SERVICE INSTRUCTION

RUNNING MODIFICATIONS ON

ROTAX® ENGINE TYPE 912/914 (SERIES)

SI-912-020 R5

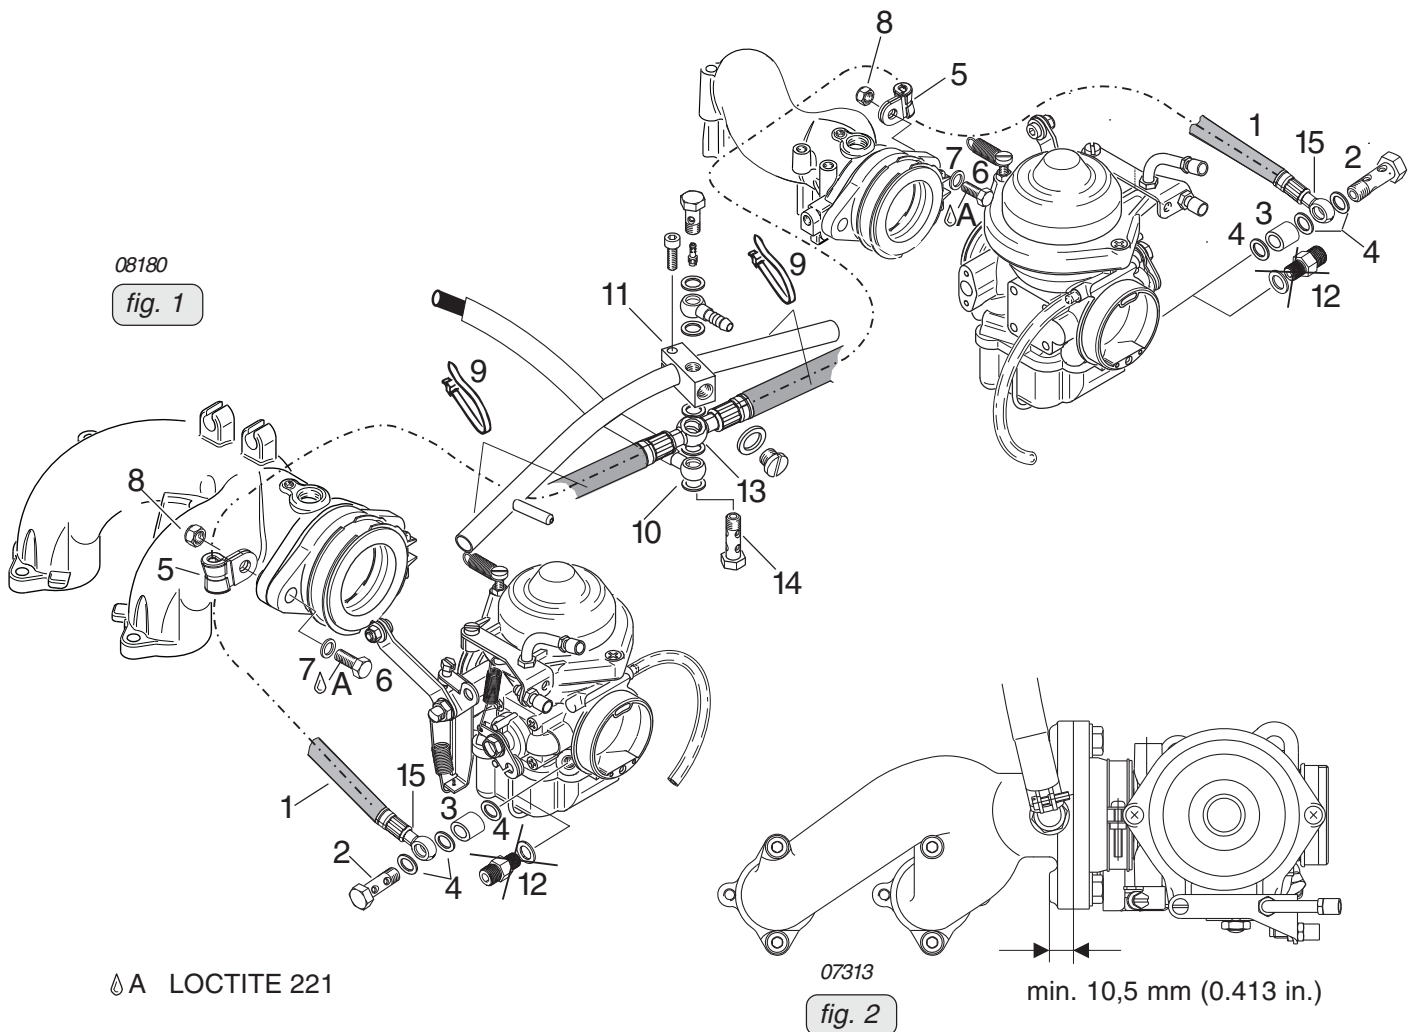
1) Introduction of a new flexible fuel line assy. part no. 874911 for ROTAX® 912 Series

In the course of continuous development and for better assembly and maintenance a new flexible fuel line (part no. 874910) has been introduced.

- mechanical machining at the intake manifold for the attachment of the cable clamp. At engine repair/general overhaul be aware that the fixation of the flexible fuel line needs an appropriate contact surface. If necessary replace the intake manifold or machine the contact surface according to the following instruction.

- Install the flexible fuel line (1) with the double ring hose nipple (13) and sealing ring (10) on the clamp block (11). Tightening torque of banjo screw (14) 10 Nm (90 in. lb.) (see fig. 1).

- Install the ring hose nipple (15) with distance sleeve (3) and sealing ring (4) on the carburetors. Tightening torque of banjo screw (2) 10 Nm (90 in. lb.)

- For installation on an old style intake manifold perform the following: Remove the intake manifold and machine the nut/clamp contact area until the surface is parallel with the sealing surface of the carb socket. The thickness of the material must not be dressed down less than 10,5 mm (0.413 in.) and should be smooth and flat so that the nut/clamp assembly has an even contact surface (see fig. 2).

- Ensure proper support of the flexible fuel line. Install Hex. screw (6) and washer (7) with 15 Nm (133 in. lb.). Install the cable clamp (5) at the hex. screw (6) of the carburetor socket with the hex. nut (8). Tightening torque of hex. nut (8) 24 Nm (213 in. lb.)

08353
fig. 1

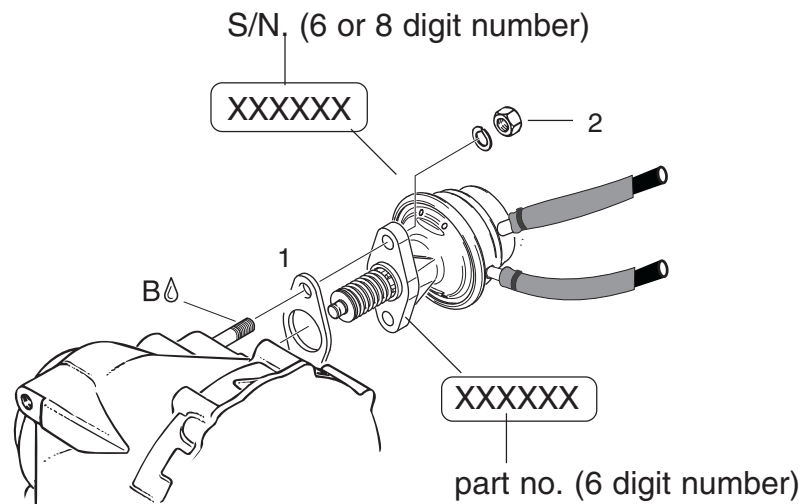
In the course of continuous development a new gasket (1) (part no. 950226) has been introduced.

- ◆ NOTE: On the sealing surfaces of the gearbox housing and the fuel pump no sealing compound has to be used.

08371
fig. 1

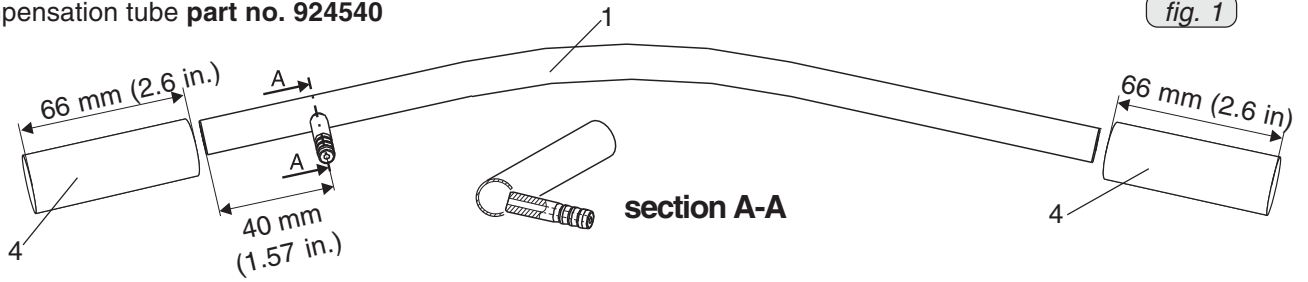
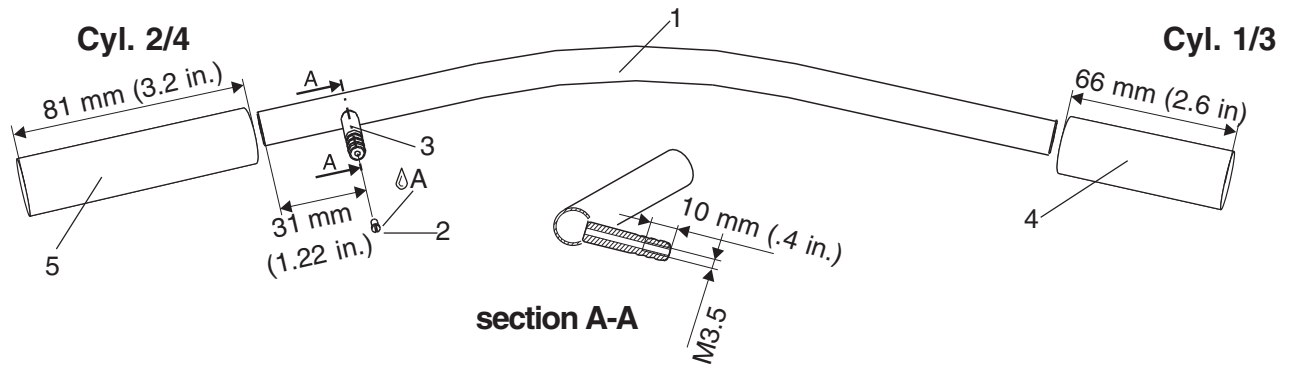
In the course of continuous development a new compensation tube (1) (part no. 924541) has been introduced which the synchronization to make it easier, the tube must not removed.

- position of connection fitting (3) on compensation tube remains approximate constant
- additional screw (2) part no. 940980 for connection fitting (3)
- new tube (4) part no. 956143 (5) part no. 956141

08449
fig. 2

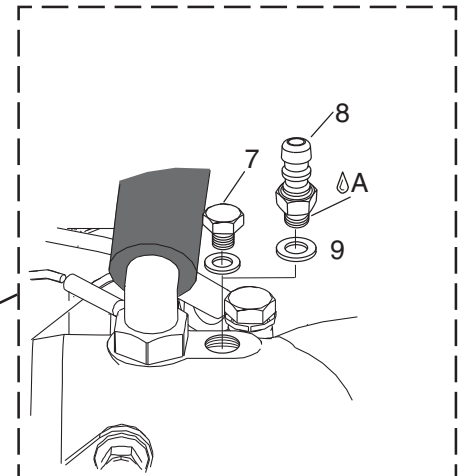
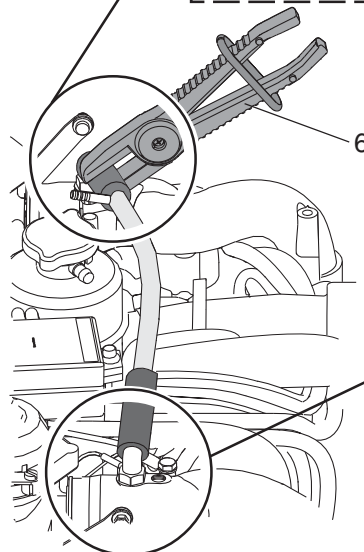
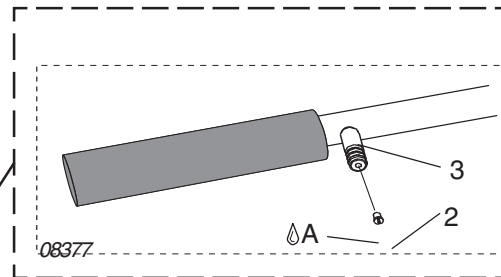
1. Install the vacuum gauge.
2. Clamp the tube with hose clamping pliers (6). Observe the position! The tube (1) must not removed.
3. Unscrew the screw (7).
4. Install the hose nipple M6 (8) with the sealing ring (9).
5. After synchronization tightened the screw M6x6 (7) with LOCTITE 221.

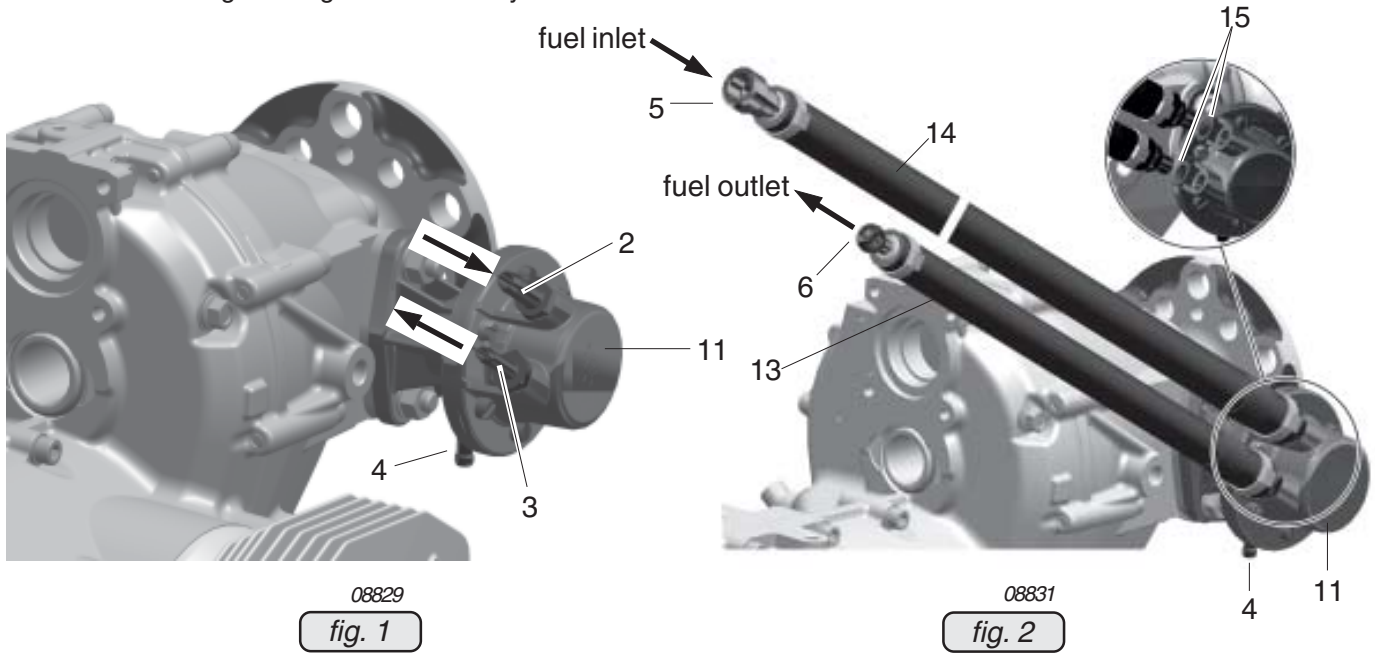
Connecting to fuel pump (1) with push-on fittings. See fig. 1.

outside dia 8 mm (0.31 in.)

slip-on length for hose attachment: max. 22 mm (0.87 in.)

Fuel outlet (3):

outside dia 6 mm (0.25 in.)

08830
fig. 3

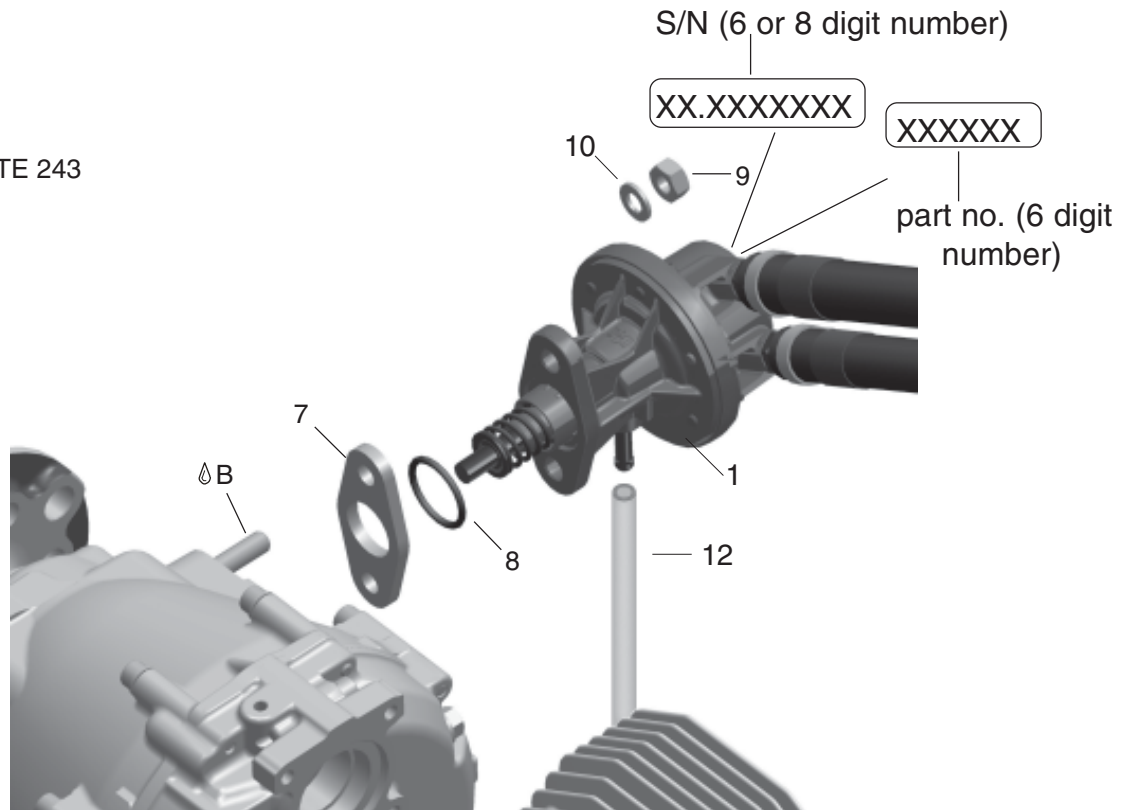
- CAUTION: The fuel pump cover (11) must not be opened. The safety marks have to be intact.
- CAUTION: The connecting fittings (2,3) must be checked for secure mounting and leakage. If the fittings or rather the fuel hoses (13, 14) have to be removed clean and reinstall with new gasket ring and LOCTITE 243 and a tightening torque of 10 Nm (90 in.lb).

Install fuel pump with new isolating flange (7) and O-ring (8). Secure and tighten equally the hex screw-nuts M8 (9) with lock washer A8 (10) using LOCTITE 243 - apply a torque of 15 Nm (135 in.lb).

fig. 1

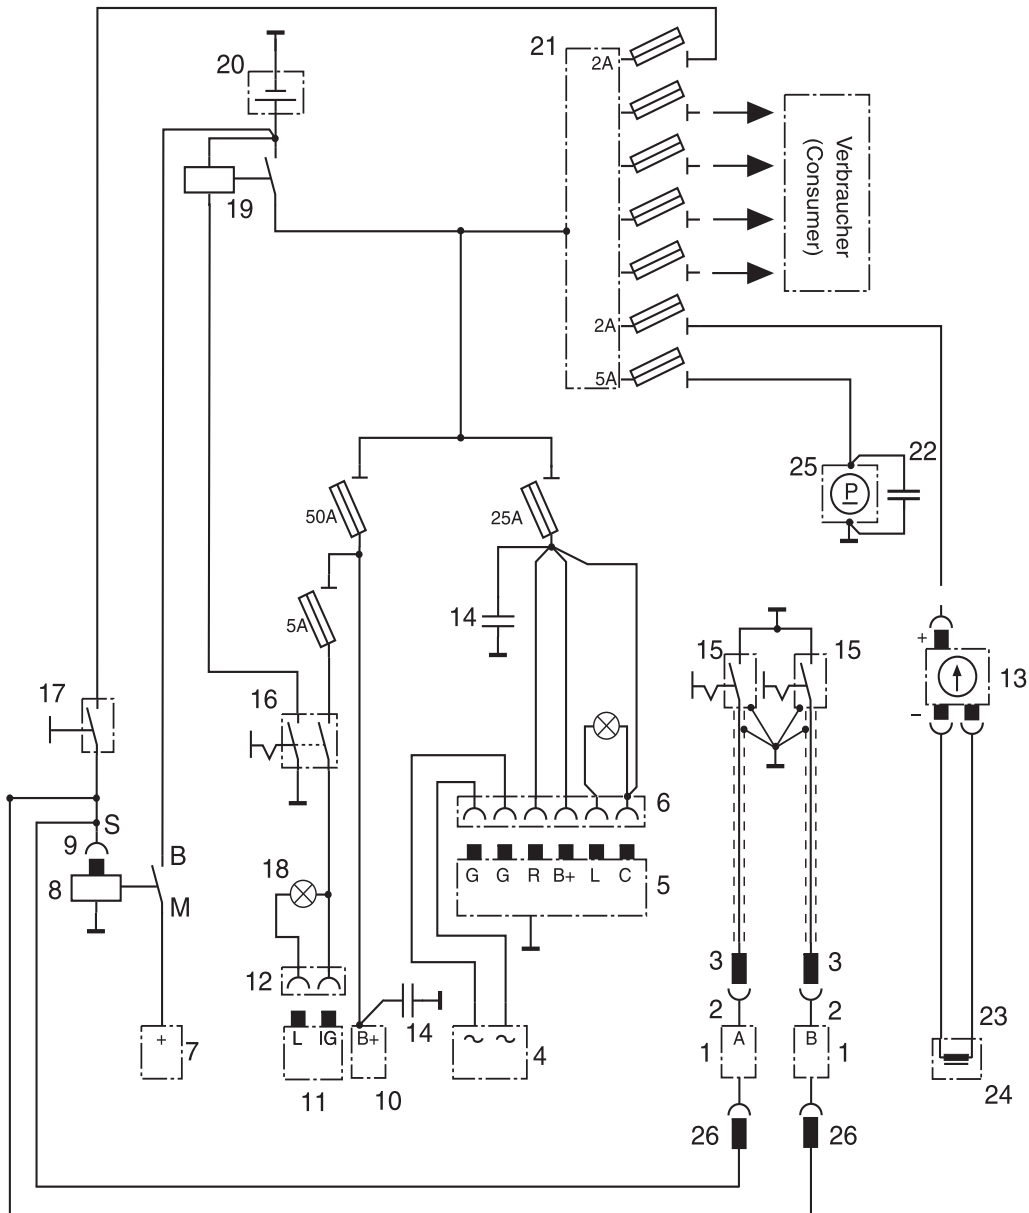
- 1 wire of each module circuit A and circuit B (6-pole) to start relay control signal wire (see position 26 in fig. 1) must be supplied by the aircraft manufacturer. Therefore the rubber plug of the pin terminal must be removed before!
- Time factor for delaying ignition timing at start until switching to advanced ignition: After starting the engine and as soon as the starter/relay is not powered anymore, the engine continues to further run for 3-8 seconds with delayed ignition.
- Do not connect the signal wire to the electric starter motor - as the circuit has not voltage protection.
- Do not power the advanced start terminal permanently with 12V. The delay timer function would be bypassed and charging speed might vary (depending on internal tolerances, trigger gap etc.).

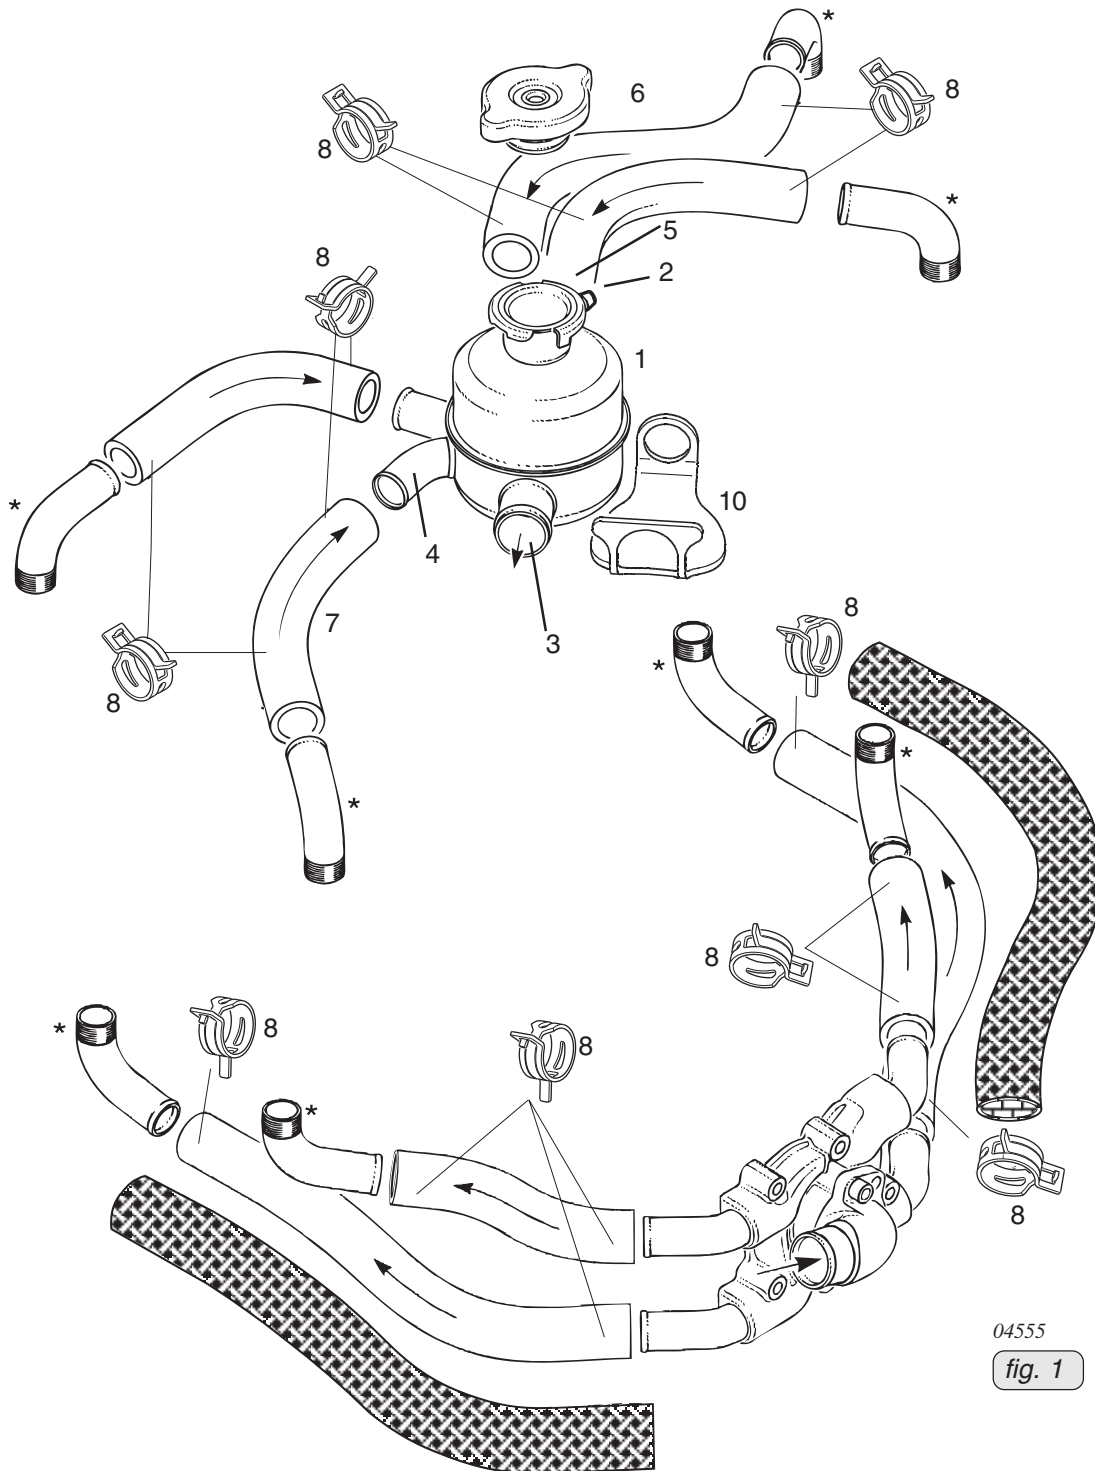
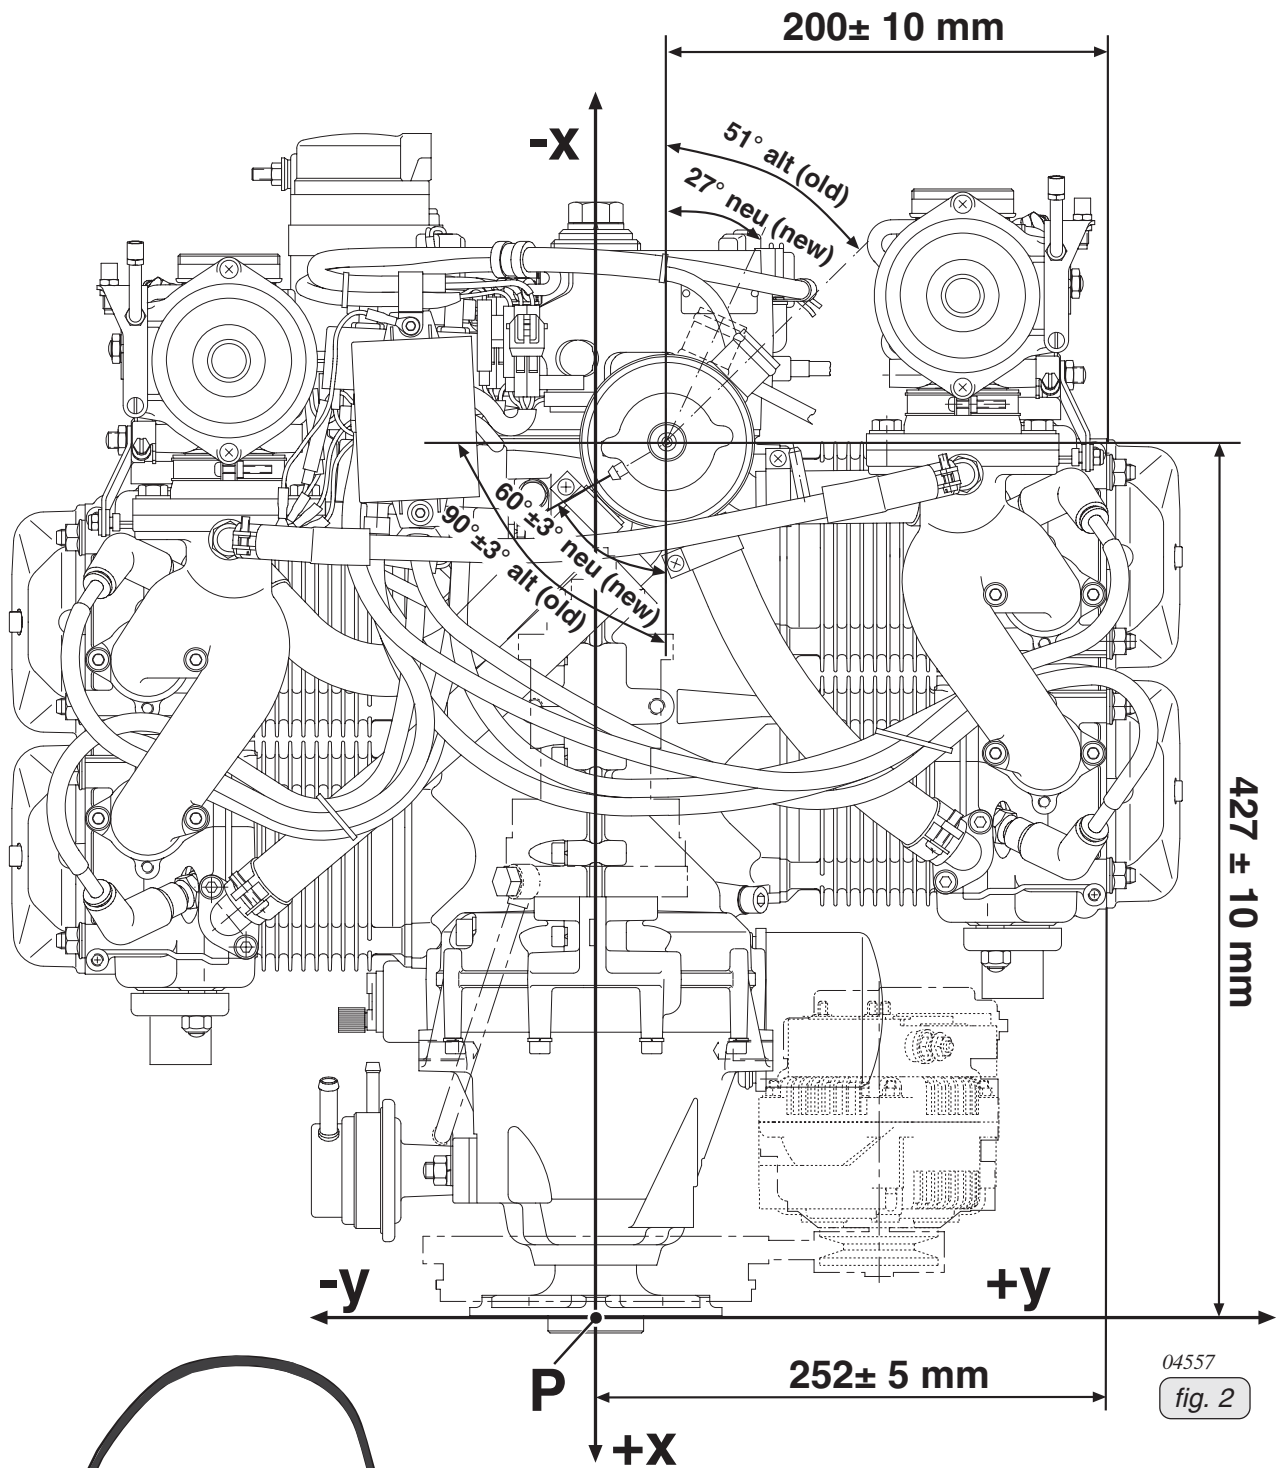
In the course of further development and standardization the position of the expansion tank (1) has been optimized!

- position of connection (2) to overflow bottle (from 0° to 30±3°)
- position of connection (3) to radiator (from 51° to 27±3°)
- angle of inlet socket (4) from cylinder 4 (34° inclined)
- length of inlet socket (5) from cylinder 3 (length increased by 13,4±3 mm)
- length of coolant hose (6) from cylinder 1 (length increased from 270 mm to 285 mm)
- length of coolant hose (7) from cylinder 4 (shortened from 100 mm to 85 mm)
- new spring type hose clamps (8) to attach the coolant hoses (expansion tank and water pump)

- Install the coolant hose (6) 285 mm to cylinder 1 and the new coolant hose (7) 85 mm to cylinder 4. For attaching all the coolant hoses from expansion tank, water pump, cylinders, use the new spring type clamps.

■ **CAUTION:** Take care of appropriate slip-on length of the coolant hoses on the corresponding connection socket. Verify tight fit of clamps and hoses and check for leakage. Always fit the clamps such that they can not wear on any component and use a suitable tool (see fig. 3) for fitting them.
